UNITED STATES PATENT AND TRADEMARK OFFICE

Office Action Summary	Application No. 10/521,000	Applicant(s) FOCKE ET AL.	
	Examiner JULIUS AGERS	Art Unit 3728

DETAILED ACTION

Reference Picture A

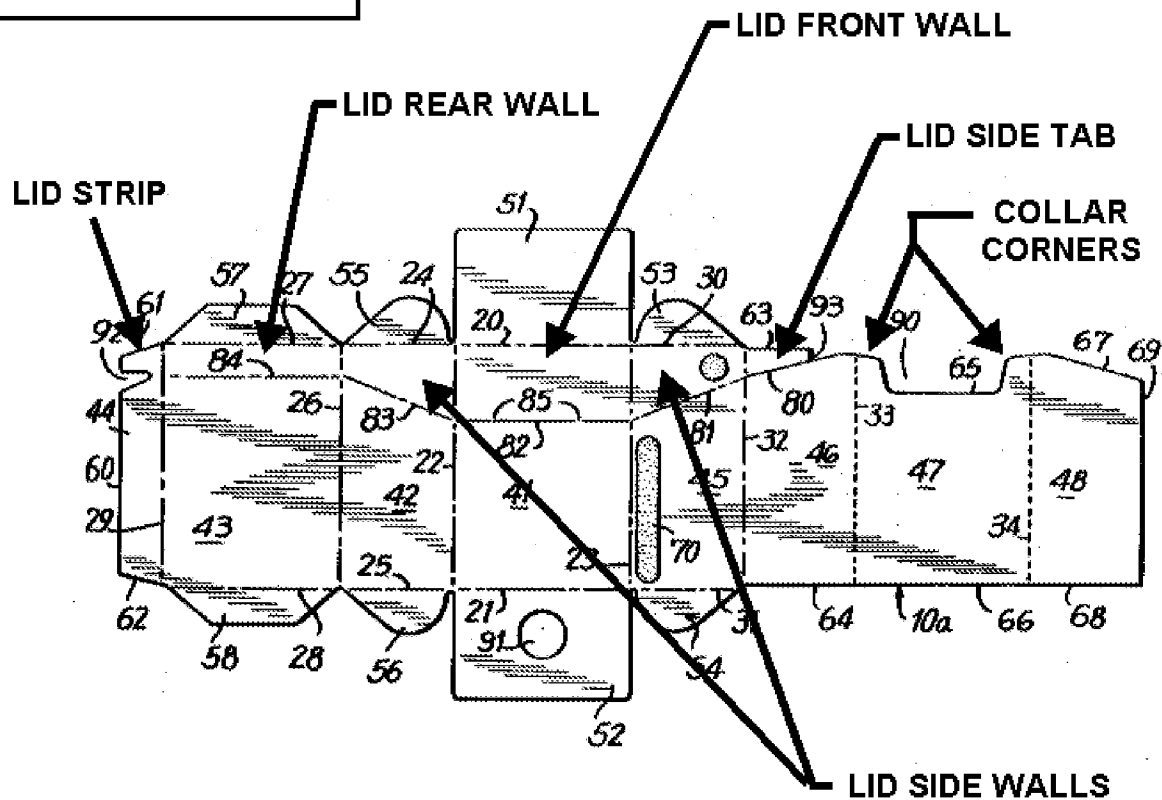
Regarding claim 1, Moore discloses a hinged-lid box for cigarettes or cigarette packs, comprising a package blank (fig. 1) made of (thin) cardboard for the purpose of

forming a box part with box front wall (41), box rear wall (43), box side walls (42) and a lid (12) having lid front wall, lid rear wall and lid side walls (see reference picture A), wherein during a production process a collar (46, 47 and 48, fig. 1), which is connected as a single piece to one side of the package blank and folded against an inner side of the package blank (connected at score line 32, fig. 1), and abutting the inner side of the box front wall (41) and the box side walls (42, see fig. 2) characterized by the following features: the package blank forms successive or continuous regions for an outer box side tab ("outside long side flap" 45, fig. 1) and lid side tab (see reference picture A), the box front wall (41) and the lid front wall (see reference picture A), the box side wall (42) and the lid side wall (wall connected to 42 via cut 83), the box rear wall (43) and the lid rear wall (connected to 43 via score line 84), as well as a marginal connective strip (44) for connecting the outer box side tab (45) and the lid side tab (see reference picture A), and the collar (46, 47, 48) is attached to a free edge (at score line 32) of the outer box side tab (45).

Regarding claim 2, Moore discloses a package blank having punched lines ("cuts" 82, fig. 1) for the purpose of delimiting the lid front wall, the lid side tab and the lid side wall (see reference picture A) from adjacent regions of the box part, with a plurality of spaced-apart residual connections ("points" 85, fig. 1) being formed by a transverse section of the punched line (82) in the region of the box front wall (41) and the lid front wall (see reference picture A) and a residual connection (81, 83) being formed in the middle of each oblique leg of the punched line (82) separating the box side tab (45) from the lid side tab, on one hand, and the box side wall (42) from the lid side wall, on the other hand.

Regarding claim 4, Moore discloses the collar has in a centered region of the collar front wall (47) a depression ("cutout portion" 90, fig. 1) bordered by the collar edge (65) and that the collar edge joining the depression has a straight oblique sloping configuration proceeding from collar corners (see reference picture A).

Regarding claim 16 and 17, Moore discloses the collar comprising a collar front wall (47) and lateral collar flaps (48, 46) and is delimited by an upper collar edge (80, 65, 67) which assumes an oblique sloping configuration at least in the region of lateral collar flaps (48, 46) and wherein a centered region of the collar front wall a depression (90) bordered by the collar edge (80, 65, 67) and that the collar edge joining the depression has a straight oblique sloping configuration proceeding from collar corners (see reference picture A).

Reference Picture B

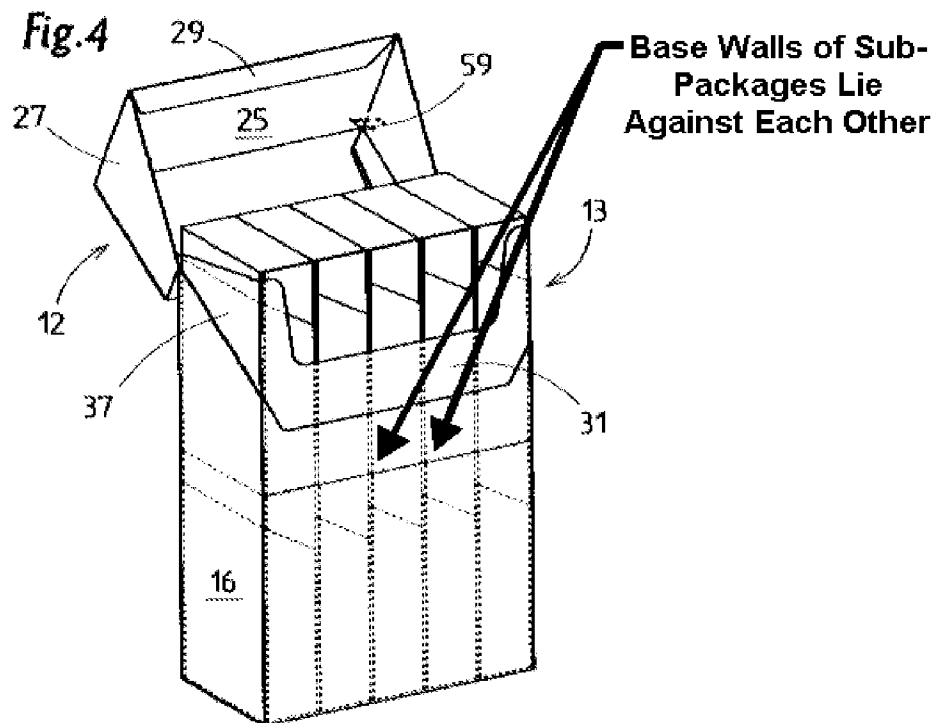
Regarding claim 20, Focke discloses a hinge-lid box for cigarettes or cigarette packs, comprising a package blank (fig. 1) made of thin cardboard for the purpose of forming a box part with a box front wall (14, fig. 1), a box rear wall (15), box side walls (16, 17) and a lid (12) having lid front wall (25), lid rear wall (26) and lid side walls (27, 28, fig. 3), and with a collar (13) abutting the inner side of the box front wall (14) and the box side walls (16, 17, see figure 4) characterized by the following features:

at least two hinge-lid boxes are joined as sub-packages (top and bottom half of fig. 4) to form a multipack unit, and the sub-packages lie with base walls against one another and are connected detachably to one another in the region of the base walls (see reference picture B).
